HISTORIC AND DESIGN REVIEW COMMISSION

October 20, 2021

HDRC CASE NO: 2021-529
ADDRESS: 313 E LOCUST
LEGAL DESCRIPTION: NCB 1738 BLK 3 LOT 3, EXC W 2 FT OF S 116.7 FT
ZONING: C-2,H
CITY COUNCIL DIST.: 1
DISTRICT: Tobin Hill Historic District
APPLICANT: Eduardo Garcia/Stantec
OWNER: Travis Feste/STALLION TEXAS REAL ESTATE FUND LLC
TYPE OF WORK: Construction of a 2-story primary and rear accessory structure
APPLICATION RECEIVED: October 01, 2021
60-DAY REVIEW: Not applicable due to City Council Emergency Orders
CASE MANAGER: Stephanie Phillips

The applicant is requesting conceptual approval to construct two, 2-story duplex structures on the vacant lot addressed 313 E Locust.

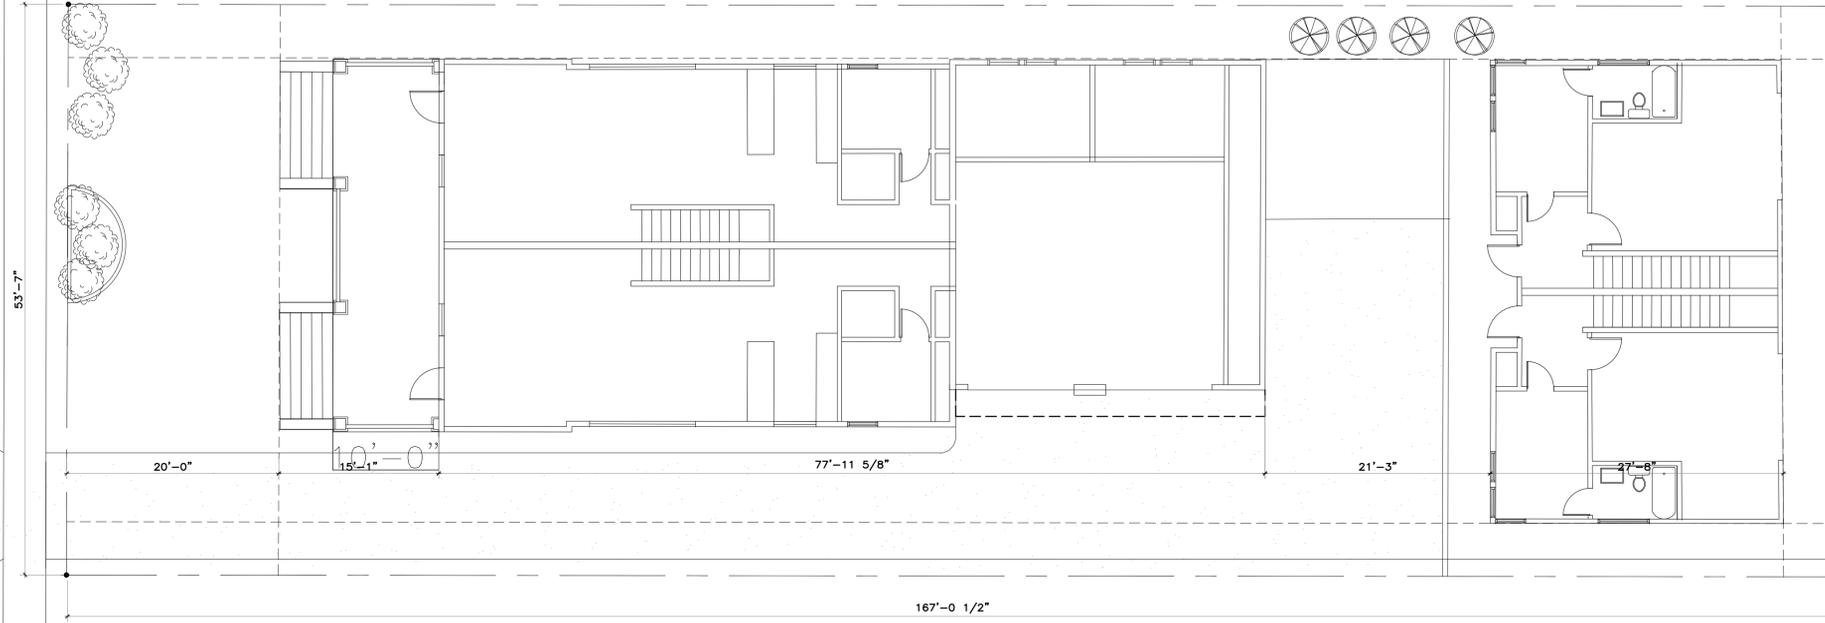
- g. **SCALE & MASS** – The applicant has proposed two, 2-story units. One will be located along the street frontage of E Locust and one will be located at the rear of the property, directly adjacent to an existing alley. Per the submitted elevations, the ridgeline of the front 2-story unit is approximately 34'. The ridgeline of the rear unit is approximately 28 feet. Guideline 2.A.i stipulates that the height and scale of new construction should be consistent with nearby historic buildings and should not exceed that of the majority of historic buildings by more than one-story. Per the submitted documents, the applicant has indicated that the 2-story historic structure directly to the east is approximately 35' in height. The rear 2-story structure does not overwhelm existing alleyway structures in terms of height. Staff finds the overall height of the structures generally consistent with the Guidelines, but requires a measured, accurate block elevation for evaluation of height for final approval.

- i. **ROOF FORM** – The applicant has proposed a front gable roof form the front structure and a side gable roof form for the rear structure. The front structure also features side dormers and exposed rafter tails. The rear structure features large decorative gable vergeboarding and eave brackets. As noted in finding a, the predominant architectural styles of this portion of the Tobin Hill Historic District, as well as the district overall, are Prairie, Queen Anne, and Craftsman. The adjacent building to the west, outside of the historic district boundary, features Monterey influences. Staff finds that gable roof forms with dormers are consistent with the Guidelines and patterns in the historic district, but finds that the large decorative gable vergeboarding on the rear structure should be removed due to its lack of precedence historically in the district.

- n. MATERIALS – The applicant has proposed materials that include lap siding, shingle siding, faux stone veneer siding and column bases, and asphalt shingle roofing. Staff finds that the proposed stone veneer should be removed due to its lack of precedence in the district historically.

- iii. That the large decorative gable vergeboarding on the rear structure be removed as noted in finding i.
- iv. That detached garages or parking areas be utilized instead of attached garages in the primary structure as noted in finding m.

- vi. That the applicant removes the faux stone siding and columns and proposes a material that is more consistent with the Guidelines and materials found historically in the district as noted in finding n.

1 OVERALL SITE PLAN
SCALE: 1/8" = 1'-0"

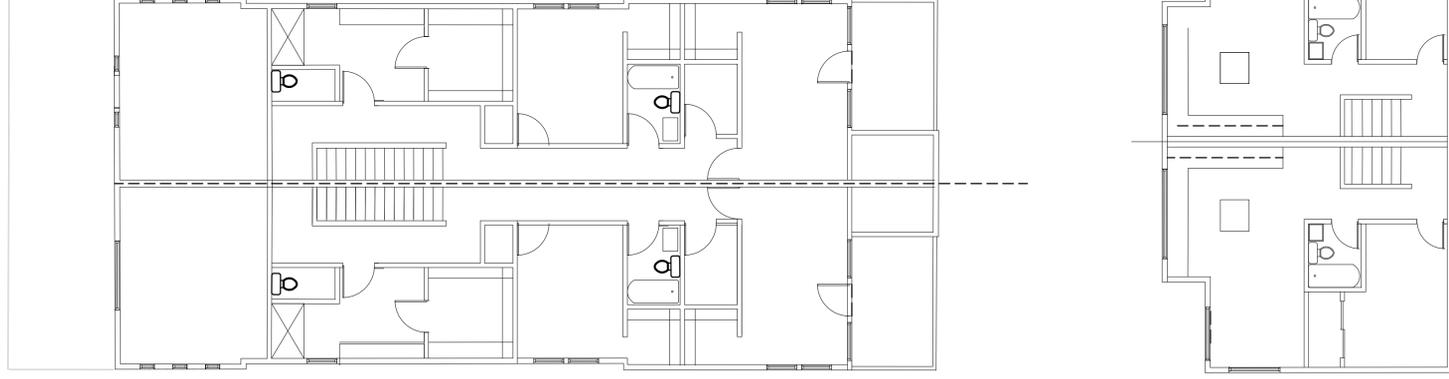
- e. **SETBACKS** – According to the Guidelines for New Construction, the front facades of new buildings are to align with front facades of adjacent buildings where a consistent setback has been established along the street frontage. This block of E Locust contains historic structures that feature front yard setbacks of approximately 20-35 feet. Based on the submitted documentation, the neighboring historic structure to the east has a front setback of approximately 32 feet. The historic 1-story structure two lots down has a setback of approximately 18 feet. The applicant has proposed a setback of 25'-4". While the proposed setback is close to the median between those of the historic structures that exist on the same block of E Locust, its placement would be approximately seven feet closer to the sidewalk than the historic structure immediately adjacent to the east. Staff finds that the setback should be increased to be compatible with the immediate context of the block. Staff also finds that an accurate, measured setback diagram should be provided.

the size of total lot area. The applicant has proposed to locate two units – one with a footprint of approximately 3,000 square feet and one with a footprint of approximately 1,200 square feet – on a lot featuring approximately 9,130 square feet. The proposed lot coverage is approximately 45%, which is generally consistent with the Guidelines. However, based on findings e and g, staff finds that the front setbacks should be increased.

- m. GARAGES – The applicant has proposed attached garages for both structures. The garages in the rear accessory structure face the alley, which is consistent with the development pattern of the block. The garages on the primary structure are located on the east elevation facing the side drive, embedded within the mass of the structure. Per the Guidelines, the predominant garage orientation found along the block should be matched. Do not introduce front-loaded garages or garages attached to the primary structure on blocks where rear or alley-loaded garages were historically used. Staff finds the attached garage configuration on the primary structure inconsistent with the Guidelines. Staff finds that detached garages or parking areas should be utilized instead of attached garages in the primary structure.

- i. That the applicant increases the setback of the front unit to be more consistent with the adjacent 2-story historic structure as noted in finding e. An accurate, measured block setback diagram is required.

- vii. That the applicant proposes a driveway width of 10 feet with an apron that flares to a maximum of 12 feet as noted in finding q.
